Sedan Range

05.1-09

TECHNICAL BULLETIN

Uneven Cold Idle – Drivability Enhancements – ECM Upgrade

ILLUSTRATION 3

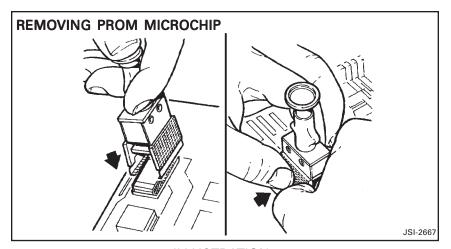
- 5. Use a suitable chip removal tool to carefully remove both PROM chips from the printed circuit board (Illustration 3). The PROM removal tool supplied may differ from that shown in the illustration.
- 6. Before installing the new microchip(s), identify the semicircular cutouts in both the chip and the socket on the printed circuit board (Illustration 4). The two cutouts **must be aligned** as the chip is inserted into the socket.

ILLUSTRATION 4

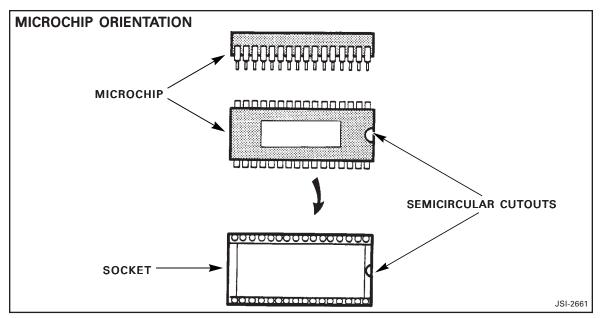
7. Identify and install the replacement 28-pin chip from the kit into the 28-pin socket and the 32-pin chip into the 32-pin socket.

ILLUSTRATION 5

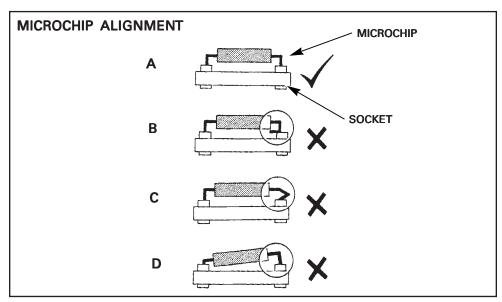
CAUTION!The microchip **MUST** lie parallel to the printed circuit board with all the pins engaged into the socket (conditionA, Illustration 5). Permanent damage to the chip is likely in conditions B or C. Malfunctions will occur with partial engagement as in condition D.

ILLUSTRATION 6

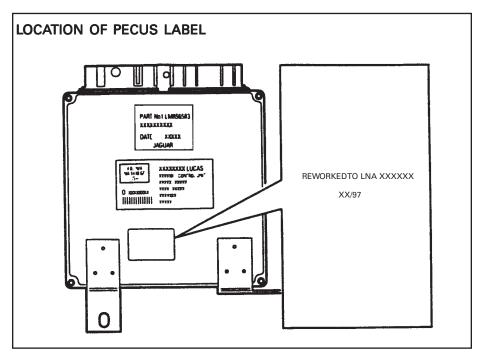
- 11. Apply the PECUS label from the kit to the cover near the existing labels without covering them (Illustration 6).
- 12. Install the ECM by reversing the removal procedures.
